**Brief of evidence of Richard George Seville relating to 593 Colombo
Street for hearing week commencing 12 December 2011**

Date: 9 December 2011

Project Name 593 Colombo Street
 Project No: 105380.71
 S.R. No: I
 Date: 4 October 2010
 Reviewed By: Paul Roberts

Figure 1

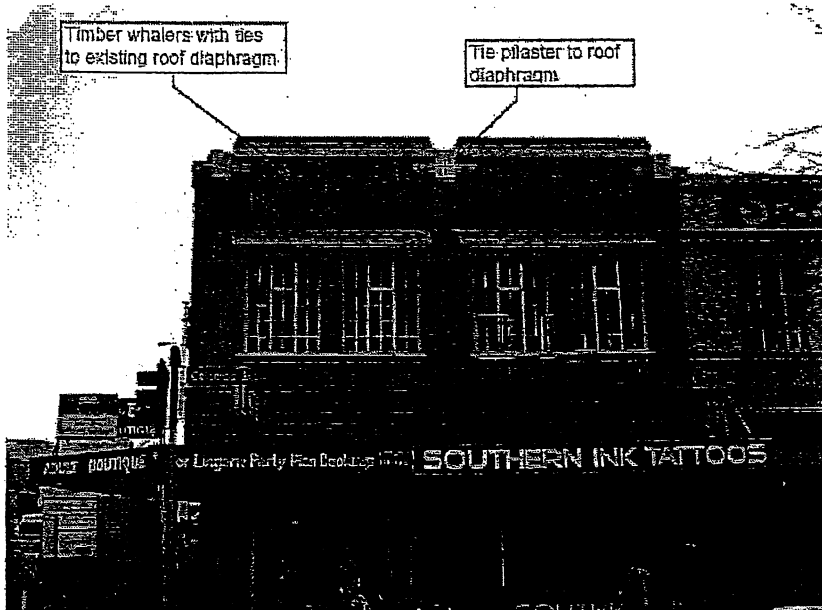
1. On the east wall, HCG observed a 10-20mm gap between the timber framed floor and brick façade. This displacement was also observed from outside. See Figure 1 for a suggested temporary strengthening scheme.
2. At the south wall, a 10-20mm gap was observed between the timber framed floor and brick façade. See Figure 2 for a suggested temporary strengthening scheme.
3. At the West wall, above the 1st floor ceiling, the brick wall appears to be leaning outwards. See Figure 3 for a suggested temporary strengthening scheme. The top of this wall may require removal depending on further investigation.
4. At the North side, no gaps between the floors and brick walls was observed. The façade appears to be in good condition.

105380.71 SK1

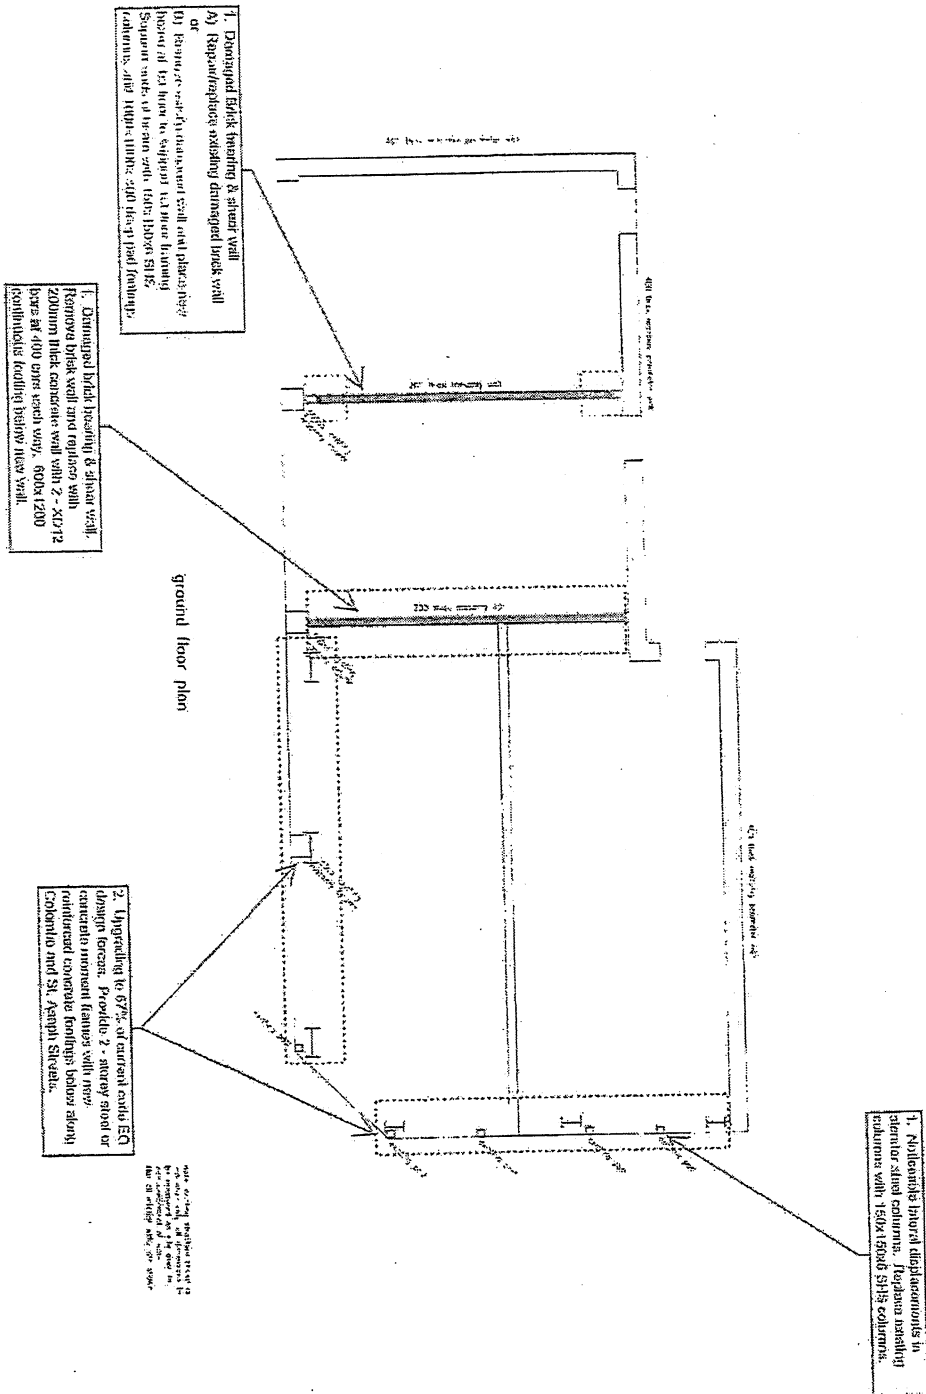
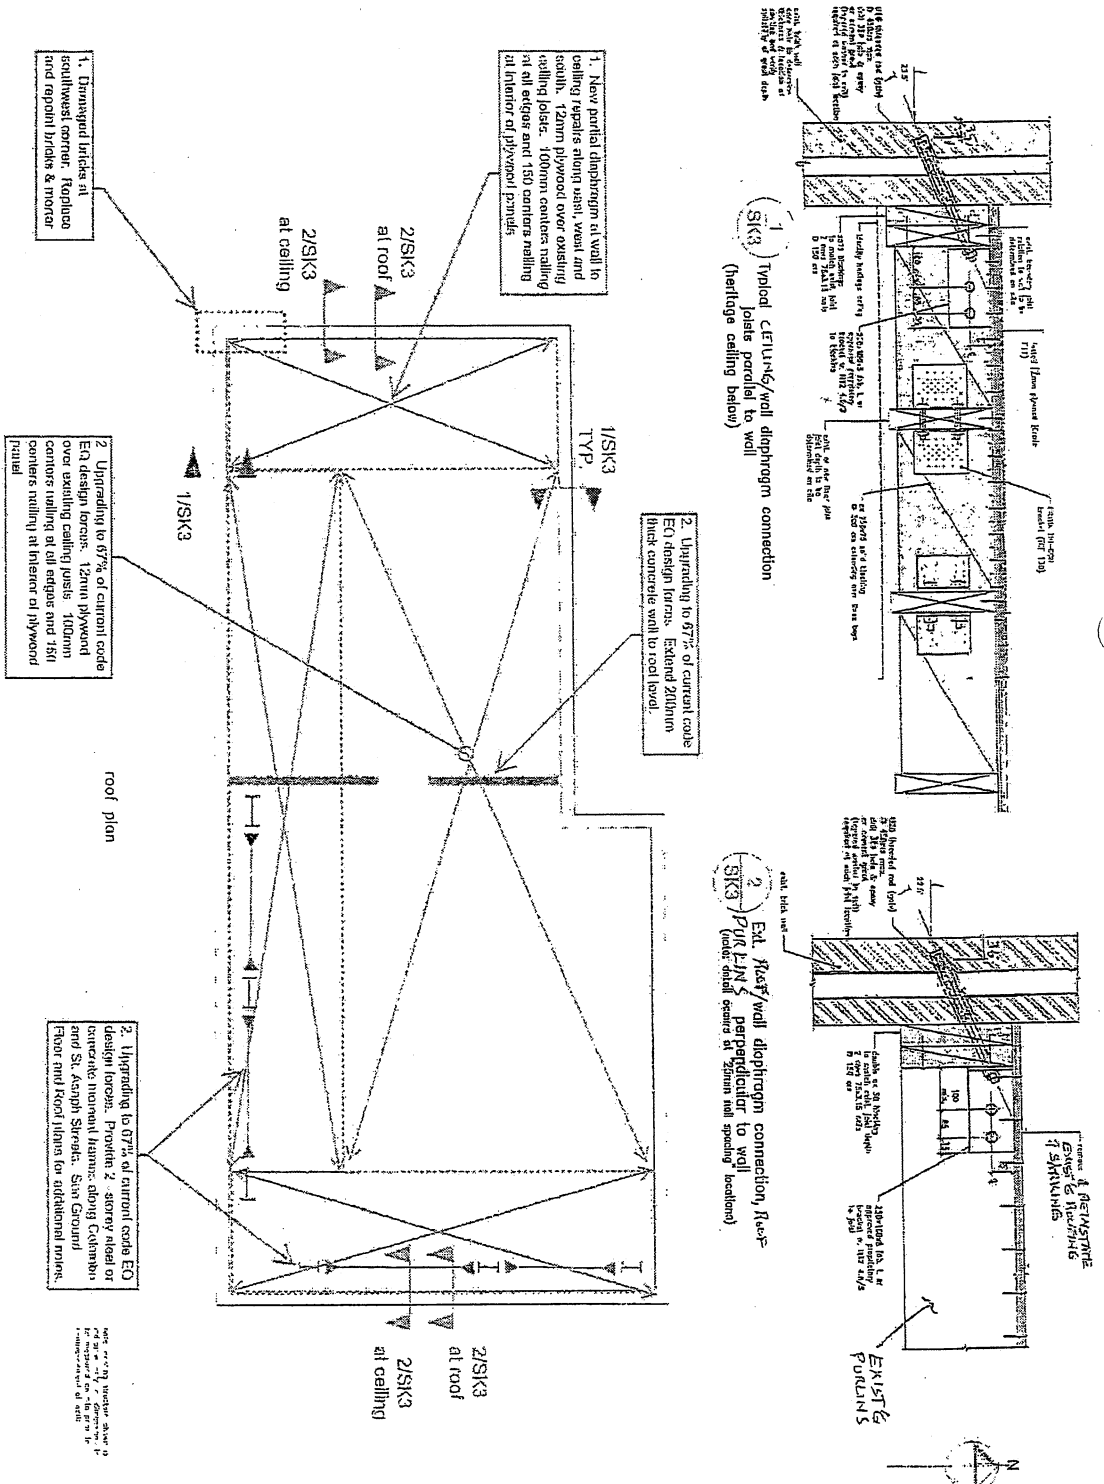
I've attached mark-ups showing the general concept for strengthening of this building. It has been split into what is required to be done now (for occupancy) and what is required to aim for 67%.

<p>Concept Design for E.O. repairs and required structural work</p> <ol style="list-style-type: none"> 1. Required repair: prior to reconstruction of deck/wall. Damaged structure must be returned to its original strength. Damaged non-structural portions shall be removed or replaced. 2. Required repairs are marked in RED. 3. Alternate options for these items are marked in GREEN. 4. Required seismic upgrade to 67% of the existing jurisdictional code, by September 2013. These items are marked as BLUE on the plans. 	
<p>693 COLUMBO ST CHRISTCHURCH</p>	
<p>22/211 PAR Council for Planning 105380.71 SK3</p>

SK2

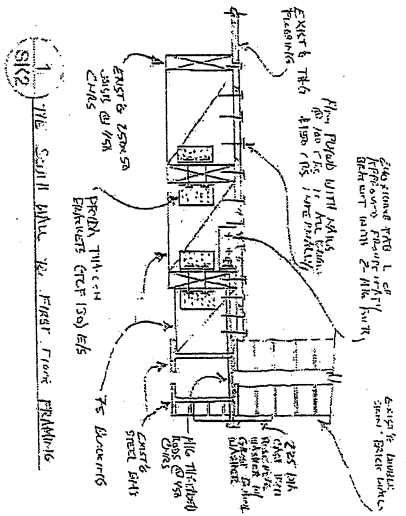
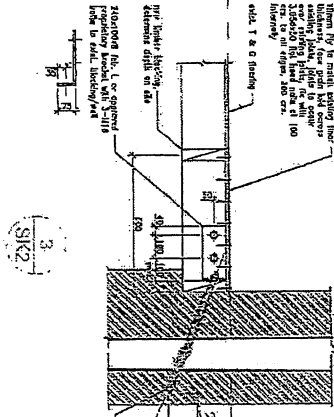
2. Typical ext. floor/wall diaphragm connection
SK2 / Floor joists parallel to wall

1. Damaged Brick bearing wall below, see ground floor plan for additional notes.
A) See ground floor plan notes
B) 40x100x7 1/2 inch form to support existing masonry above.
C) 18x18x18 inch column below to support earth load.

7. Upgrading to 67% of current code EQ design forces. Extend 200mm thick concrete wall to roof level.

2. Upgrading to 67% of current code EQ design forces. 12mm plywood over existing 7/8\"/>

2. Upgrading to 67% of current code EQ design forces. Provide 2 - storey steel or concrete moment frames along Columbus and St. Asaph Streets. See Ground Floor and Roof plans for additional notes.
